Project
Cefn Coed Colliery Museum
Renovation of two Grade II* Listed headgear frames

Sheet
Building at base of Headframe 1
Current condition and works proposed

Drawing No.	Sheet No.	Revision
CD-V-C8458.60	105B	R0

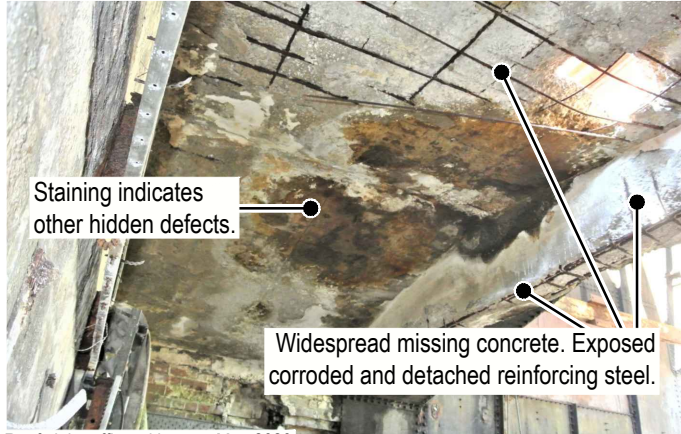
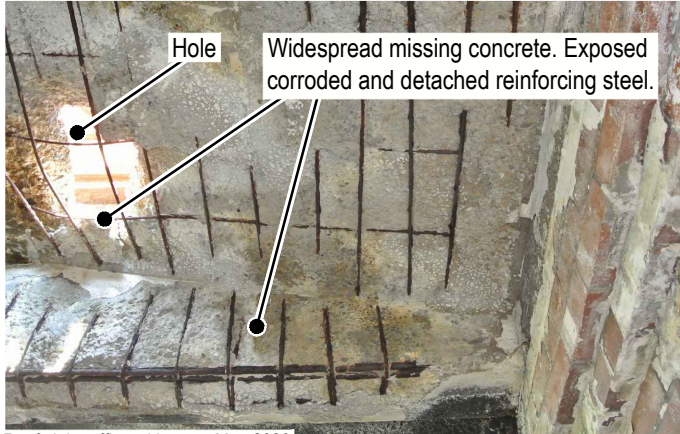
Significant deterioration of the concrete roof has occurred since the survey in April 2018 (and the basis for the Listed Building Consent granted in July 2018): holes have appeared through the slab; widespread loss of concrete across the underside of the slab and beam faces, exposing corroded reinforcing steel. Consequently, it is no longer feasible to repair the roof nor ensure it can safely remain in place whilst adjacent repairs are undertaken.

The concrete roof is of limited architectural or historic significance. It is proposed to remove the concrete roof entirely (it will not be replaced). The adjoining steel canopy will remain and be refurbished. This follows the profile of the roof and, together with the wall remains (see text opposite), will retain sufficient evidence of the form of the building.

The current proposals (granted LBC in July 2018) permits some dismantling and modification of the masonry adjacent to the steel lattice girder columns in order to reduce the risk of corrosion and improve access for repairs and future maintenance (i.e. prevent trapping of moisture and debris and permit future applications of protective paint). The masonry was to be reconstructed (albeit modified) because the concrete roof relied upon support from the walls.

As the roof is now to be removed, the modification to the wall can be adjusted to improve the access further: the extents of this is shown on the annotated photographs above (hatched light blue). Consequently, small areas of wall (hatched yellow) have the potential to become unstable, primarily due to the corbel detail or apertures formed crudely in the wall: it is proposed to dismantle these areas to safeguard the stability of the majority of the walls. The pipe which passes through the wall will be retained and supported in-situ.

This proposal retains significant amount of wall, including evidence of doorways (on the west elevation), and the overall form of the building can be understood. An option to dismantled the middle of the modern blockwork wall would improve visitor access / views through the headframe.

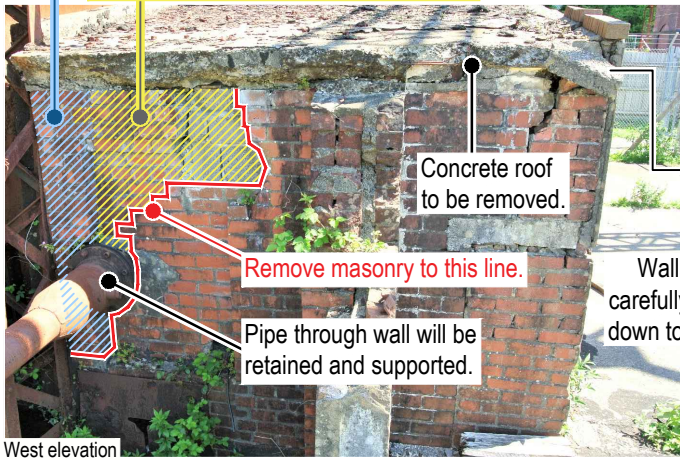
Remove this masonry to improve access for repairs and maintenance.

This masonry likely to become unstable.

Remove this masonry to improve access for repairs and maintenance.

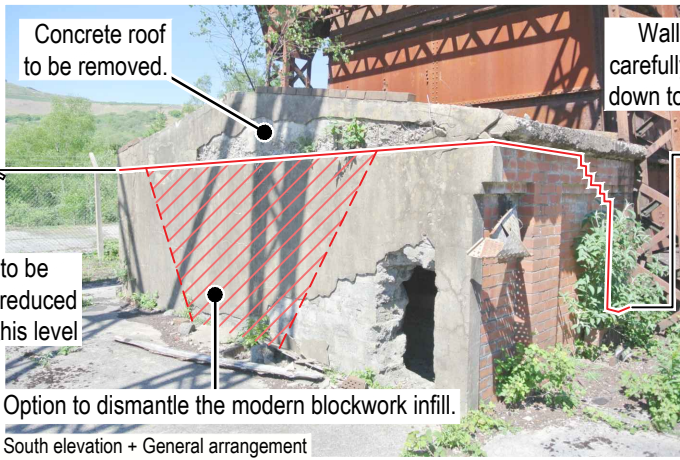
This masonry likely to become unstable.

Remove this masonry to improve access for repairs and maintenance.

This masonry likely to become unstable.
